Sydney North Planning Panel Meeting 21 April 2021
20-22 MINDARIE STREET AND 30 PINAROO PLACE, LANE COVE NORTH

Subject: 20-22 Mindarie Street and 30 Pinaroo Place, LANE COVE NORTH
Record No: DA20/181-01 - 15638/21
Division: Environmental Services Division
Author(s): Henry Burnett

Panel Reference	PPSSNH-188
DA Number	181/2020
LGA	Lane Cove Council
Proposed Development	Construction of a Residential Flat Building pursuant to SEPP (Affordable Rental Housing) 2009
Street Address	20-22 Mindarie Street and 30 Pinaroo Place, Lane Cove North
Applicant/Owner	Applicant: BCL2 Limited Owner: NSW Land and Housing Corporation
Date of DA lodgement	22 December 2020
Total number of Submissions Number of Unique Objections	<ul style="list-style-type: none"> • Eight (8) • Eight (8)
Recommendation	Approval
Regional Development Criteria (Schedule 7 of the SEPP (State and Regional Development) 2011	CIV > \$5 Million – Private infrastructure and community facilities
List of all relevant s4.15(1)(a) matters	<ul style="list-style-type: none"> • relevant environmental planning instruments <ul style="list-style-type: none"> - SEPP (Affordable Rental Housing) 2009; - SEPP 65 – Design quality of Residential Apa

Figure 19: Proposed Balcony Returns to Be Deleted (Shaded Red)

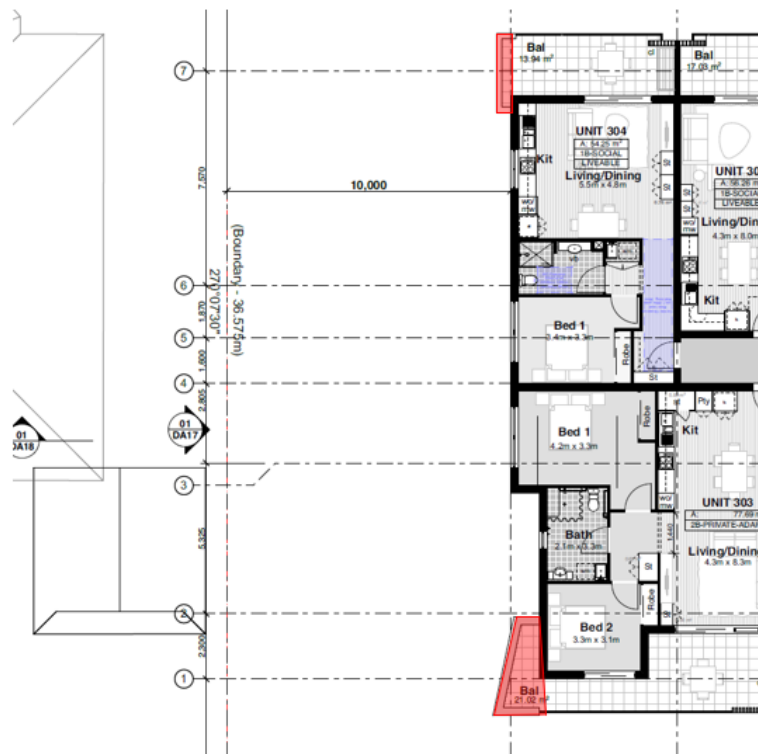
- **Building Height:** See Section 5.1.6 of this report.
- **Visual Privacy:** The visual privacy implications of the proposal to the southern adjoining property requires further consideration. If the following amendments to the design are made the proposal would be considered to not have an adverse visual privacy impact on surrounding sites:
 - o All fixed window panels on the southern elevation are to be obscure glazed (With the exception of the ground level) on **Figure 18**;
 - o All non-bedroom windows are to have a minimum sill height of 1.5m above the finished floor level; and
 - o The balcony returns projecting beyond the southern building line at Ground to Level 4 are to be deleted on **Figure 19**.

Figure 21: North/South Section Through Lift Overrun and Fire Stairs

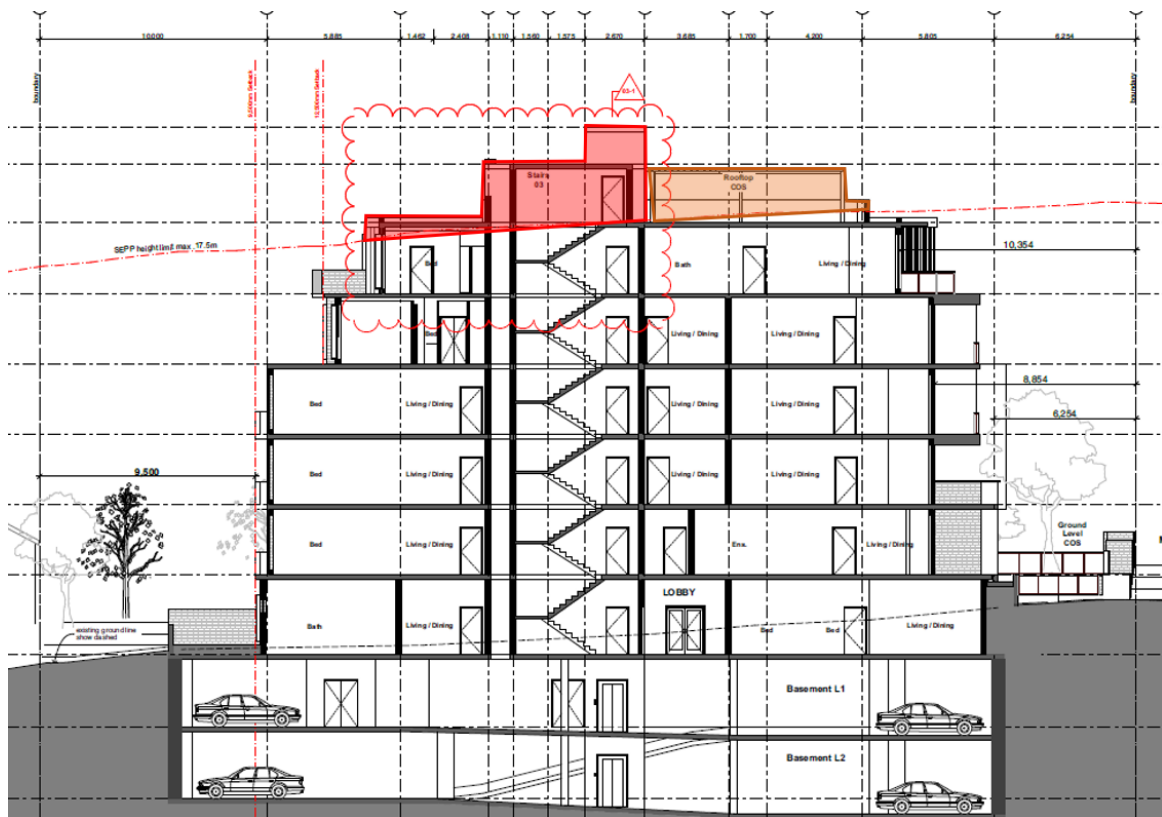
The maximum building height for the site under LCLEP 2009 is 17.5m. The proposed maximum building height is 21.38m to the lift overrun being a variation of 3.88m or 22.17%. The applicant has provided height plane and sectional diagrams to detail the proposed breach as shown in **Figure 20**, **Figure 21** and **Figure 22** below. The proposed height breach principally relates to the lift overrun and fire stairs/toilet for the rooftop communal open space. The maximum height for residential levels is 18.7m to the south-eastern edge of Unit 502 being a variation of 1.2m or 6.8%.

Figure 24: Amended 9am Mid-Winter Shadow Diagram

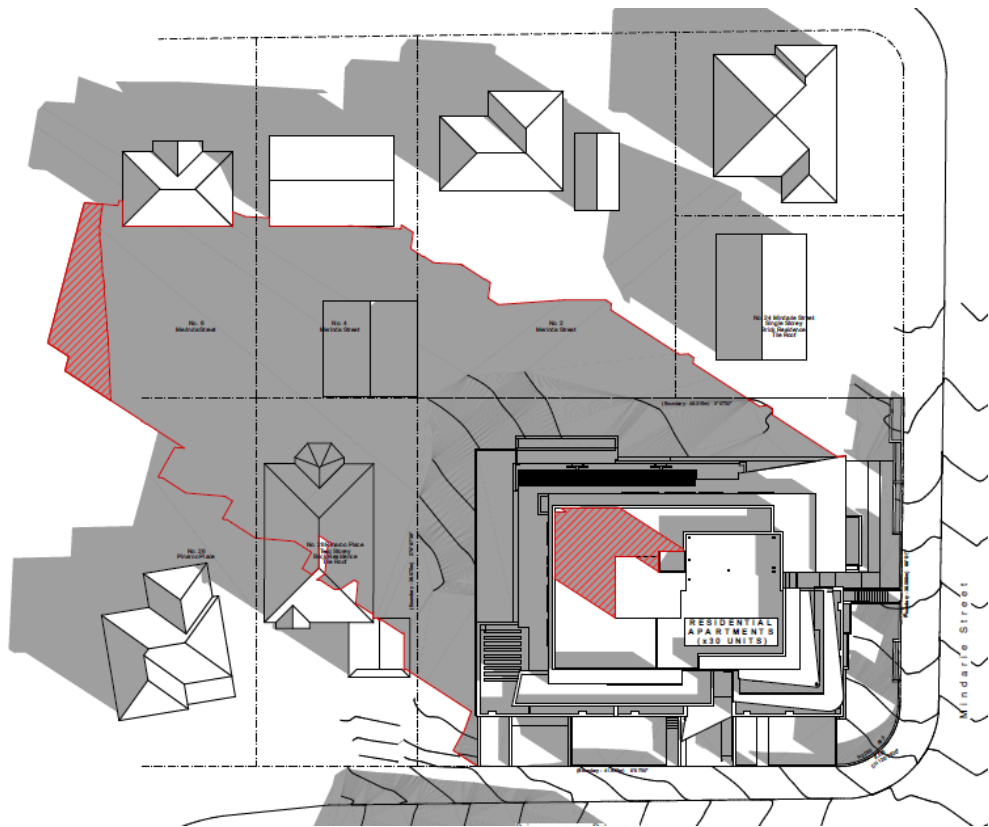
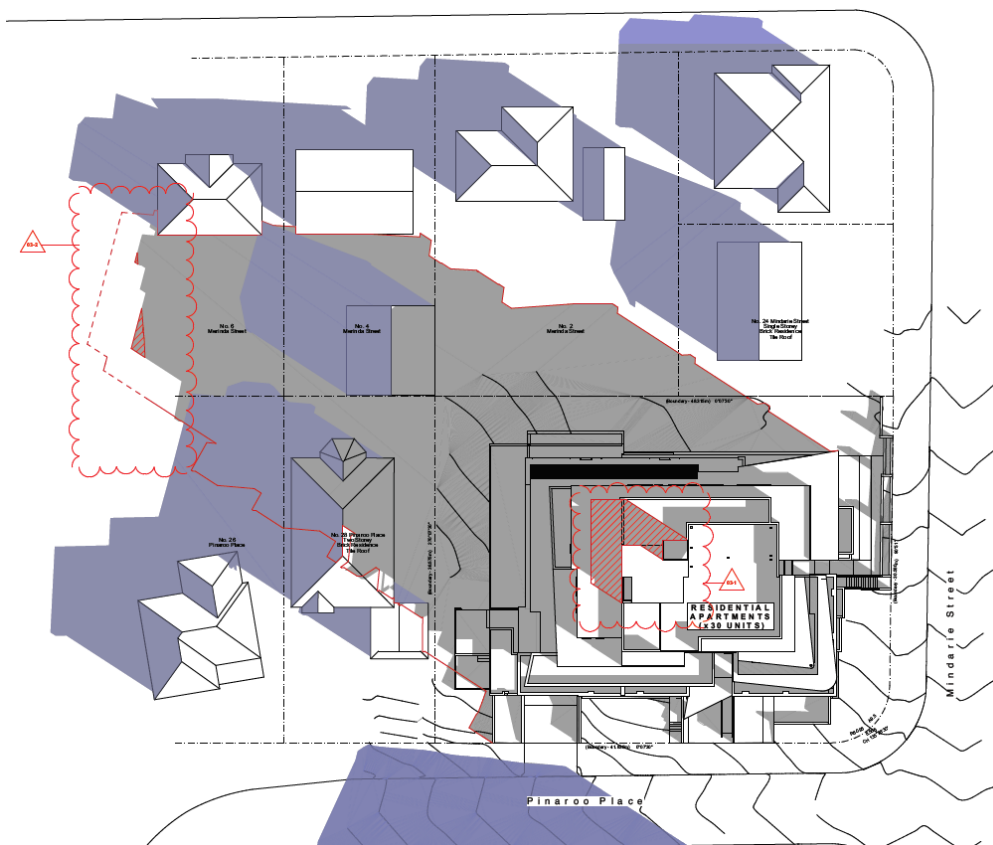
Comment: Council had concerns with the extent of overshadowing from the height breach in Revision 1 plans (**Figure 23** below). The applicant was requested to reduce the overshadowing to be more consistent with that anticipated by the local planning provisions. The proposal was amended and the shadow reduced in Revision 3 plans (**Figure 24** below). The lift overrun and associated structures do not result in additional shadow and their shadow is contained to the roof form. The additional shadow is resultant from Unit 502 only. While the deletion of Unit 502 would remove any further overshadowing, the breach has been reduced to such a small extent that the impact is considered reasonable.
